Site Characterization Work Plan Addendum
Corning Chestnut Street
Former Manufactured Gas Plant Site

City of Corning, New York
NYSDEC Site # 851035
Index No. D0-0002-9309

July 16, 2021
Project: 1904594

SURFACE AND NEAR SURFACE SOIL SAMPLES - REVISED ADDENDUM

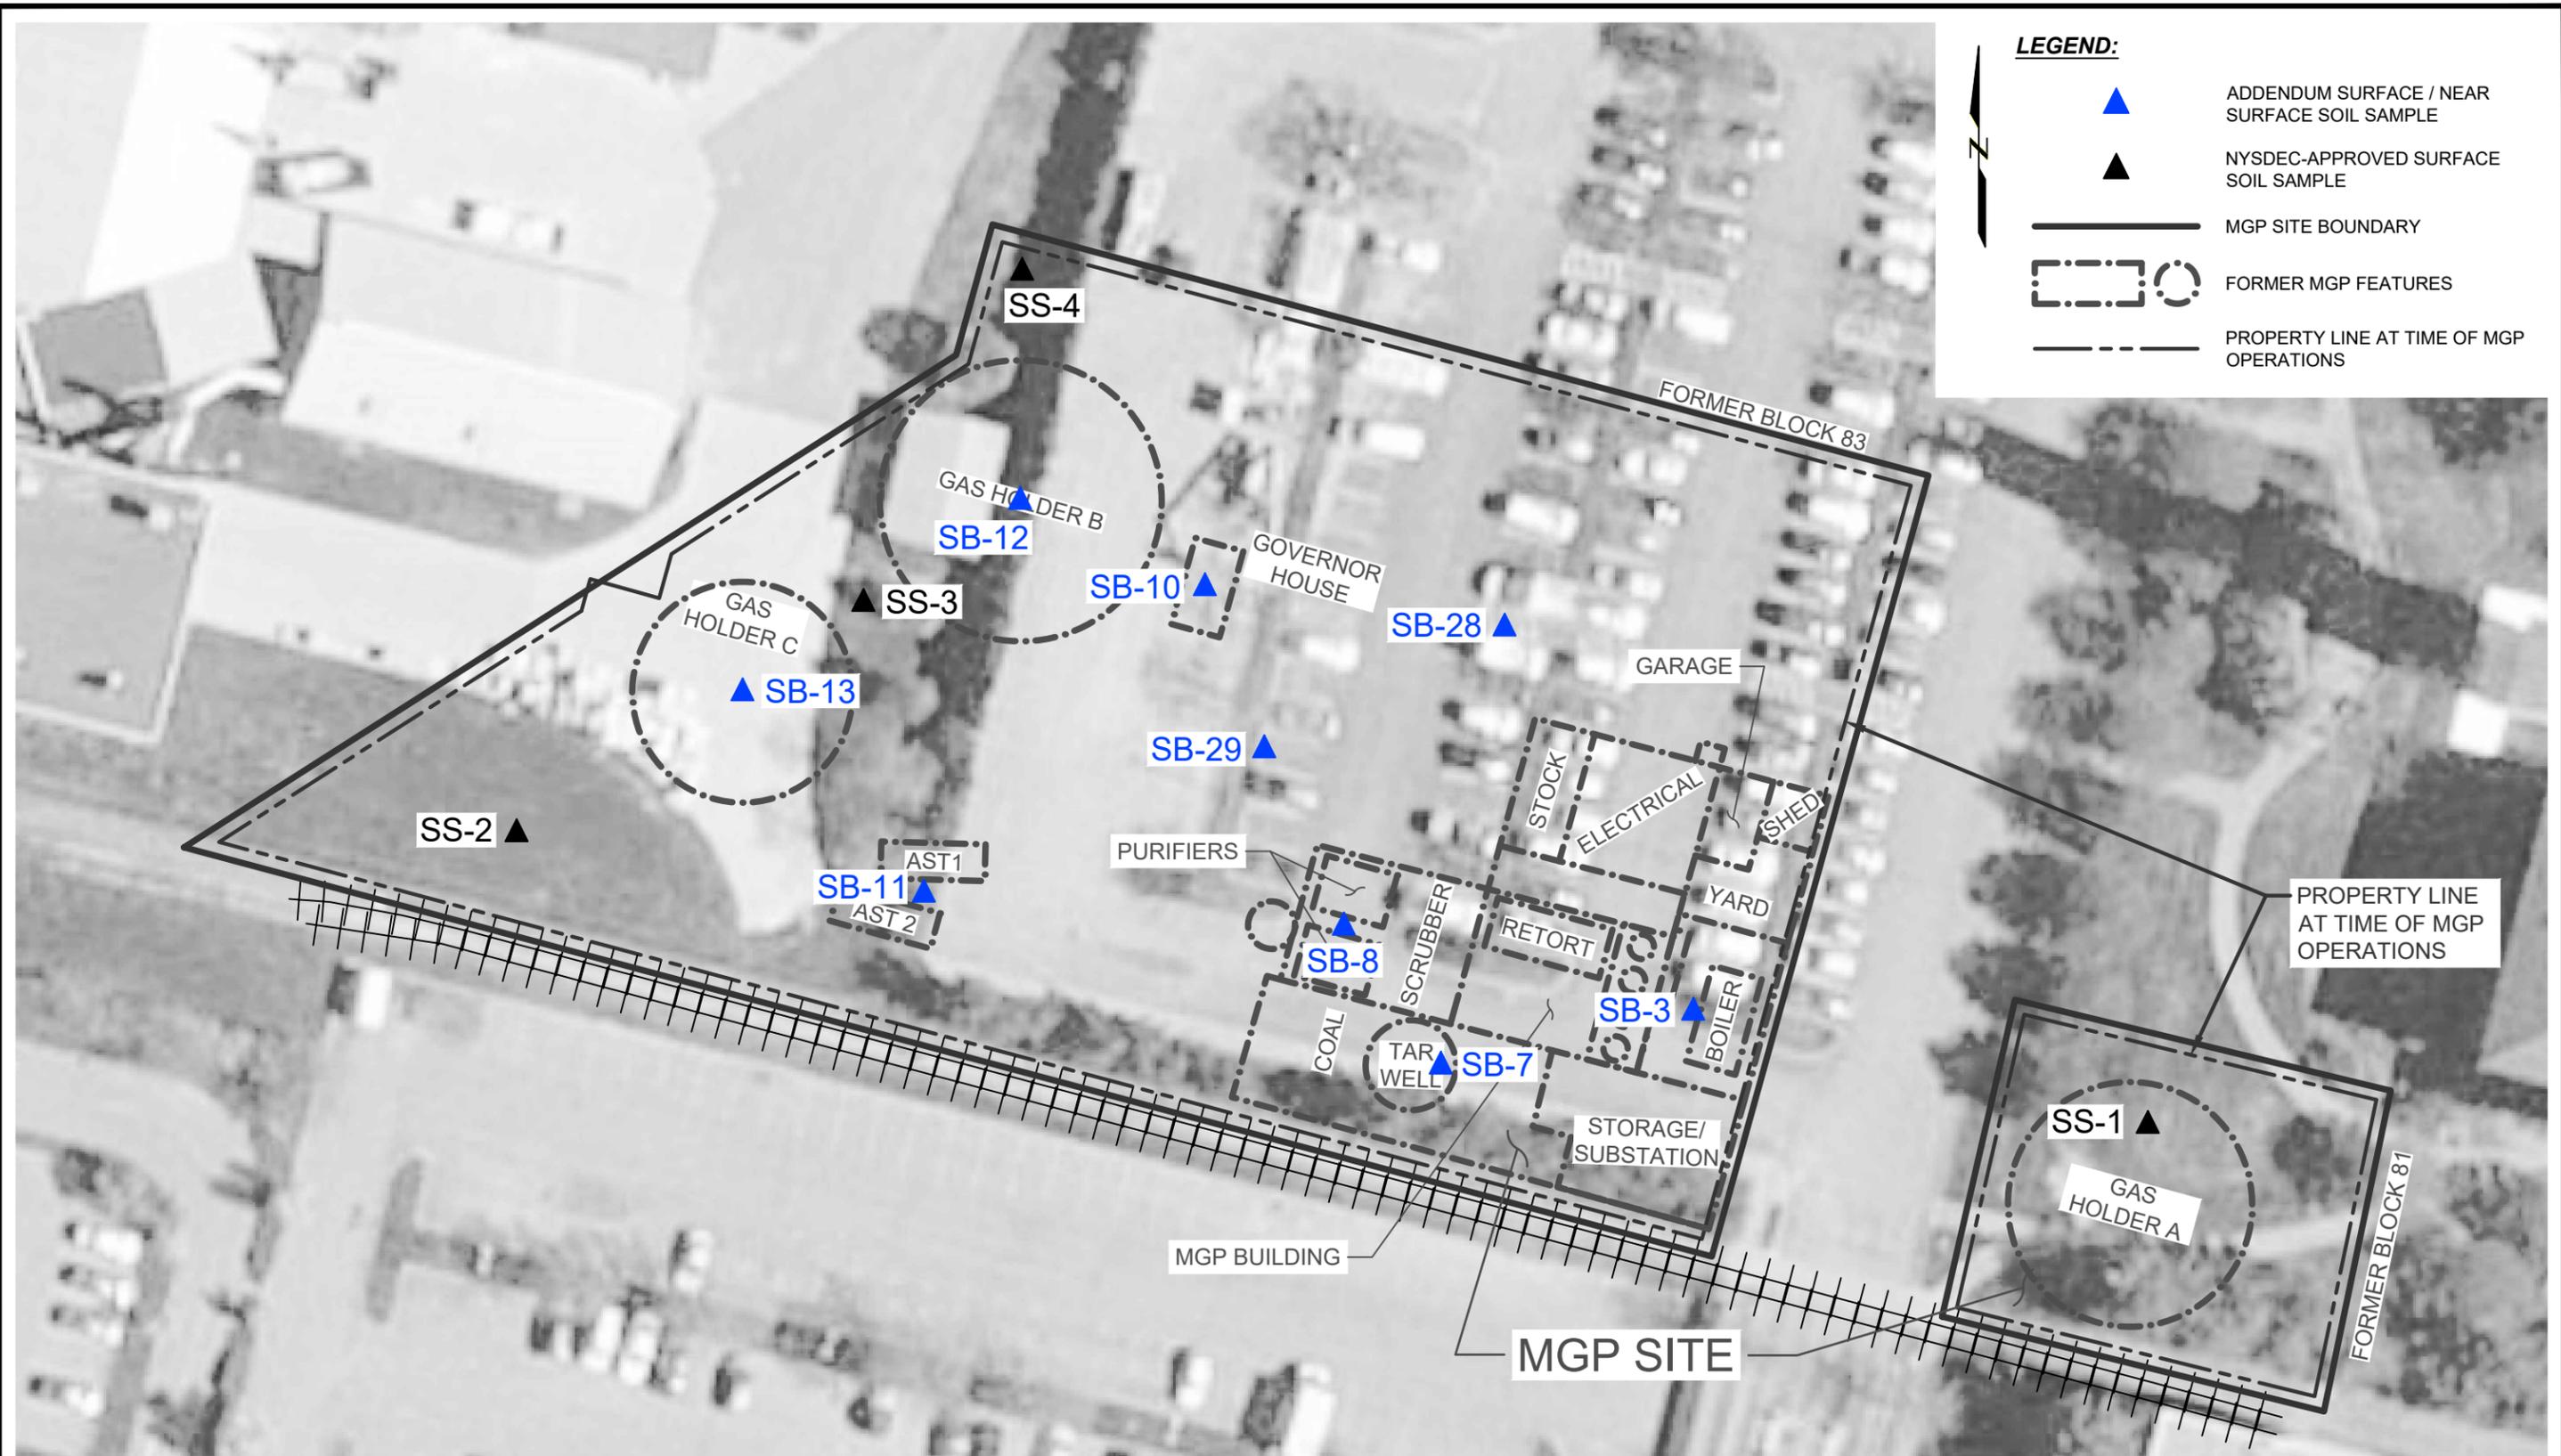
The SCWP identifies four locations for surface soil sampling in the limited areas where surface soils can be obtained from beneath grassy areas. Both 0 to 2 inch and 0 to 1 foot samples will be obtained from these locations, as shown on Figure 8A, and listed in Table 2A. These locations are SS1A/SS1B, SS2A/SS2B, SS3A/SS3B, and SS4A/SS4B. Samples of deeper fill and native soils from these areas will be part of the subsurface sampling task described in Section 3.4 of the SCWP, and expanded upon in Section 2.5 of the Addendum below.

Native or fill soils beneath paved areas are not considered surface soil for NYSDOH assessment; however, the upper foot of soil still requires evaluation by the NYSDEC for comparison to applicable site SCOs. Furthermore, as no background information regarding the source or soil quality of the fill is available, it is appropriate to include this surface soil in the analytical program for the site in order to assess future site management or remediation needs. Therefore, samples of soil within the 0 to 1 foot zone beneath pavement will be collected from nine soil borings spaced across the site to characterize the fill material, as shown on Figure 8A, and listed in Table 2A. These locations are SB3, SB7, SB8, SB10, SB11, SB12, SB13, SB28, and SB29. As these will not be true surface soil samples, they will be described in the SC investigation as “near-surface” samples. They will, however, be grouped for evaluation with the 0 to 2 inch surface soil samples.

Note that the pavement and associated granular sub-base soil material may be up to a foot thick at these locations. These surface soil samples will therefore be collected from the first foot of soil below the base of the pavement system.

Site Characterization Work Plan Addendum Corning Chestnut Street MGP Site Corning, New York			EXPLORATION LOCATIONS - REVISED FOR ADDENDUM
NYSEG New York	Project 1904594 July 2021

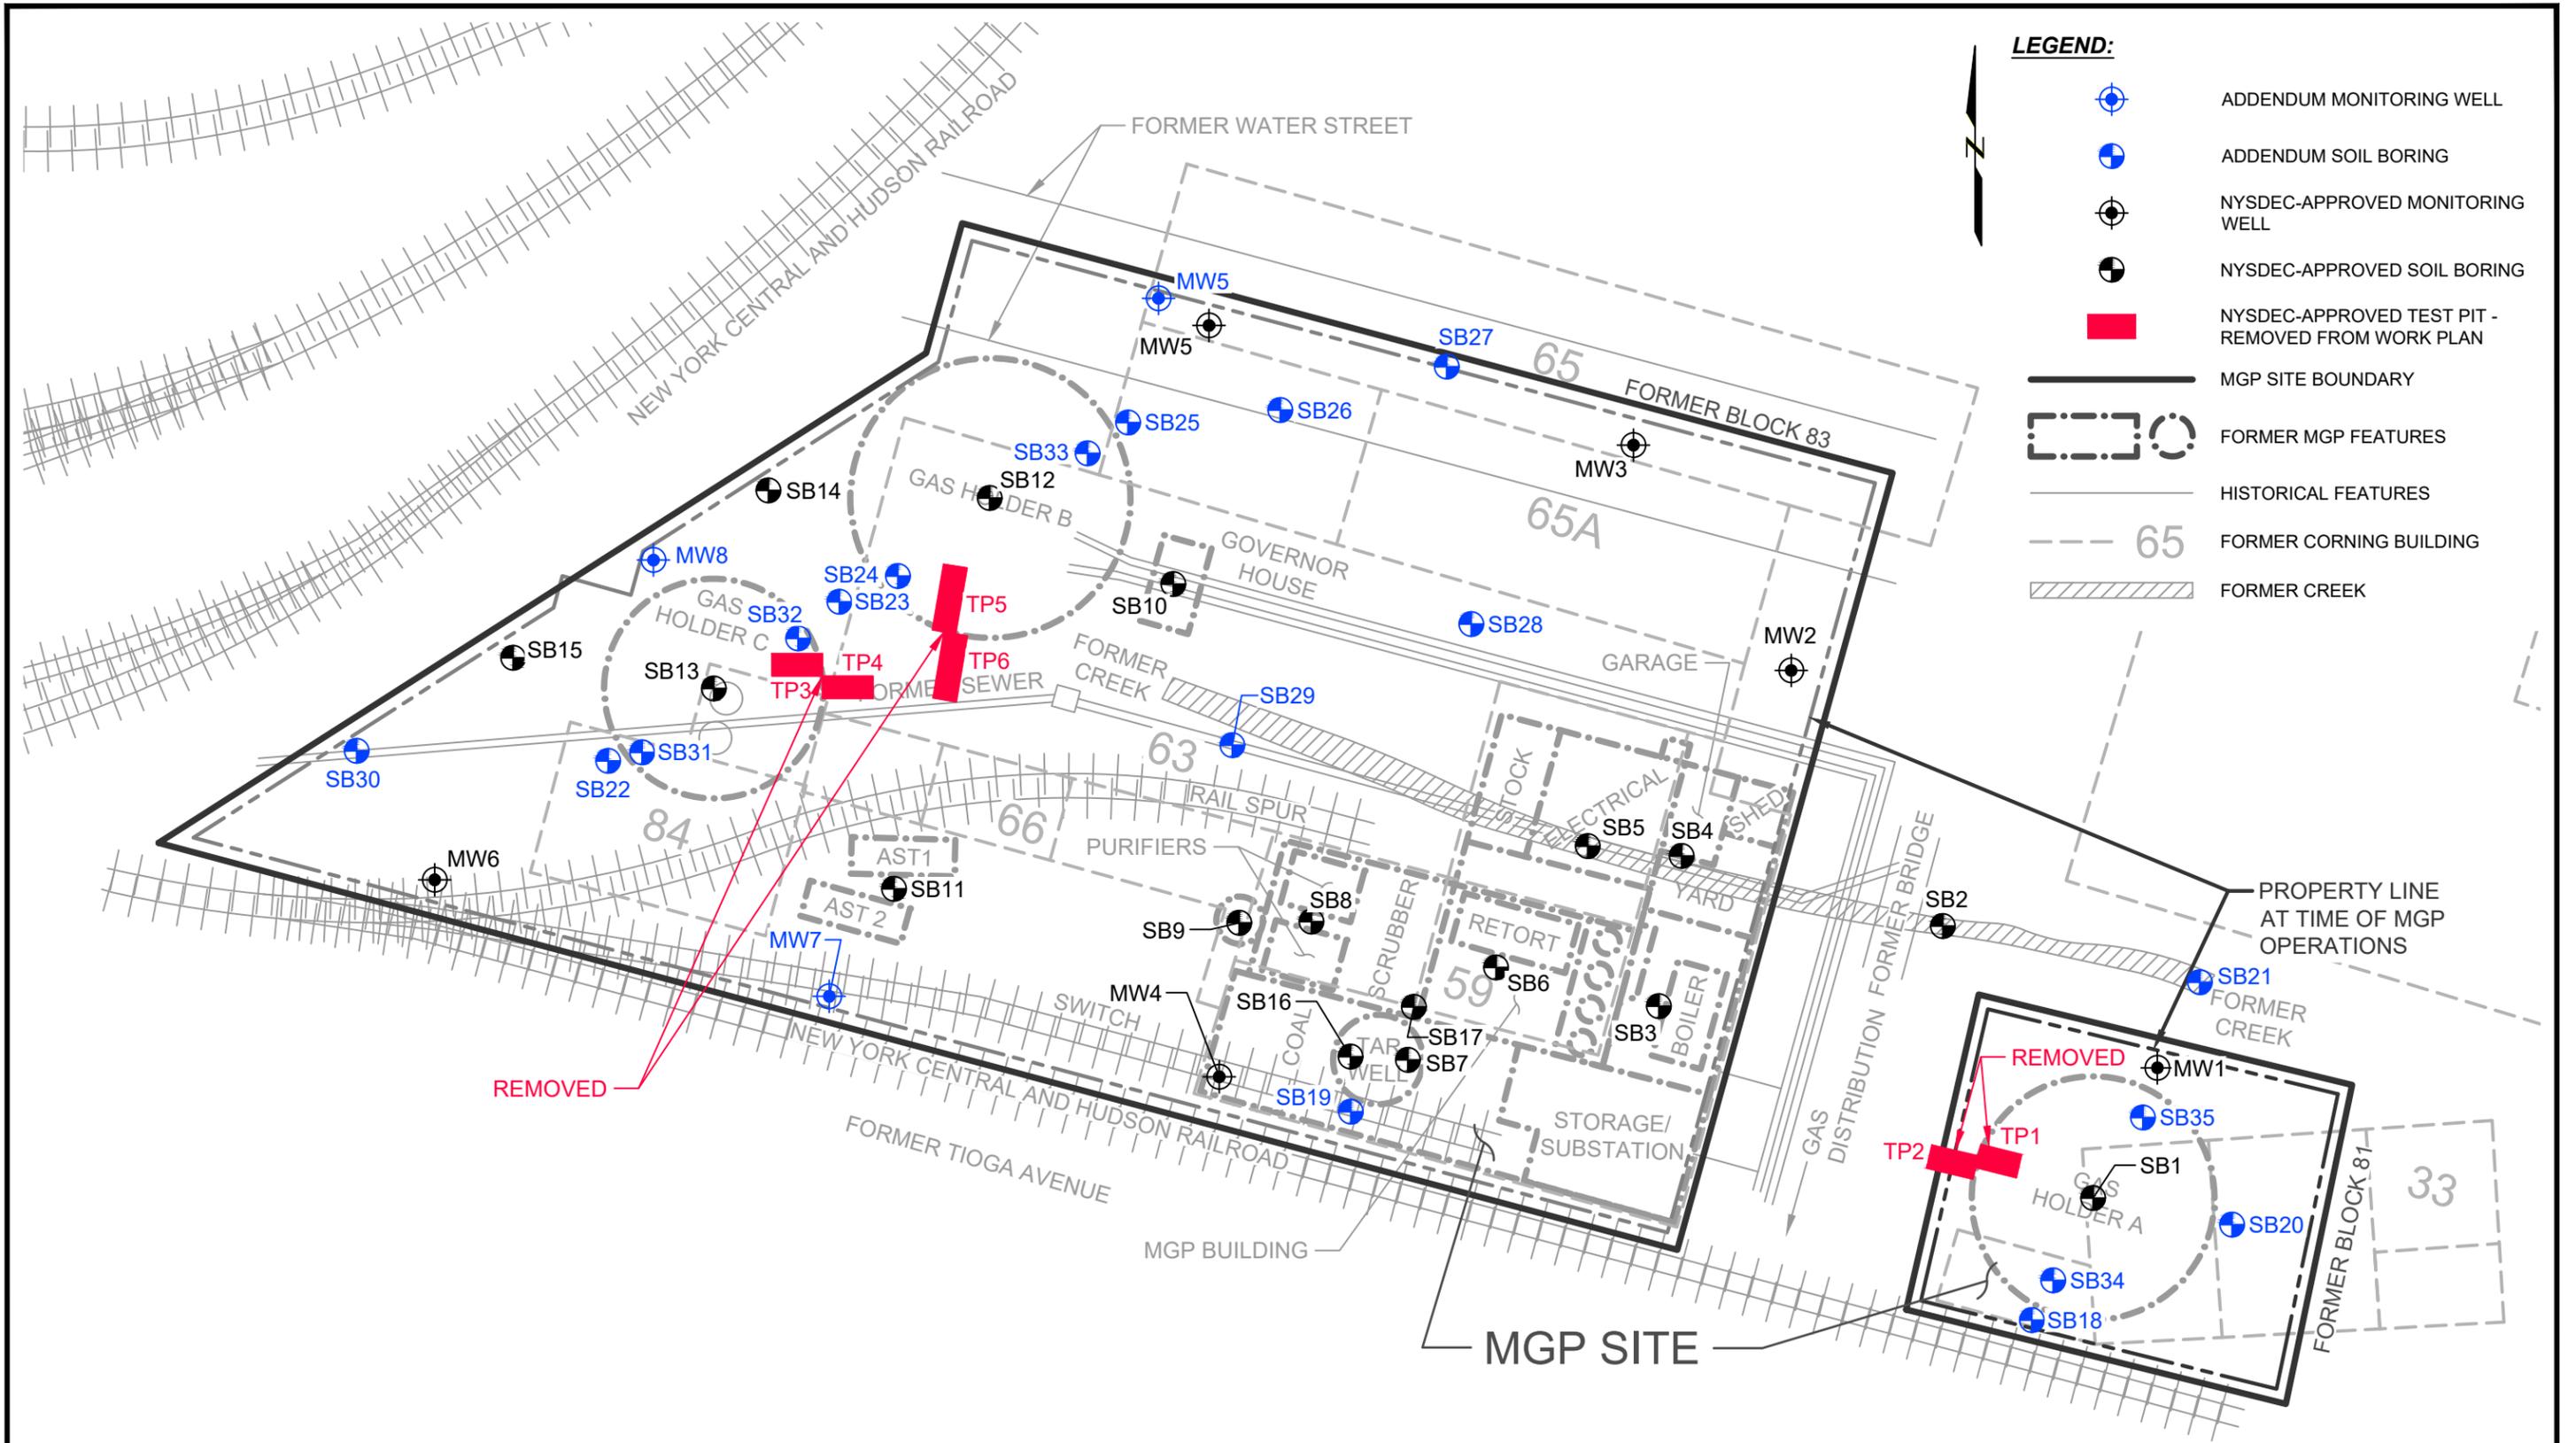
The test pits proposed in the SC Work Plan will not be performed, but instead will be replaced by several additional soil borings in and around each holder location as well as the geophysical survey described in Section 2.1. This change is made to minimize the disturbance to Corning’s

property and to minimize the potential for damage to active site utilities. The replacement borings are described below in Section 2.4, shown in Figure 9A, and listed in Table 4A.

- SB19 will be added to expand the investigation of the former tar well.
- SB20 will be added to help define conditions at the eastern side of the site near Gas Holder A.
- SB21, SB29, SB30 will be added to help investigate the location of the former creek at the site and/or the former sewer.
- Ten borings will be added to replace the test pits for the investigation of the former gas holder locations (SB-18, SB22-SB25, SB31-SB35).

- SB26, SB27, and SB28 were added to better assess conditions downgradient of the former MGP.

The locations of the soil borings are shown on Figure 9A, and they are listed in Table 4A.

Two additional monitoring wells have been added to the work plan (MW7 and MW8), as shown on Figure 9A and listed in Table 5A. MW7 will be installed between MW4 and MW6, in order to assess whether contaminants are entering the investigation area via groundwater from up-gradient off-site sources. This well was added to the SCWP based on the review of the NYSDEC spills database, that indicates that there are potential sources of groundwater impact in the presumed up-gradient location of the site and this well location. MW8 will be located along

In addition, the originally-approved location of MW5 (black) was adjusted slightly to the west (blue) as a result of the additional coverage provided by new soil borings SB25, SB26, and SB27.
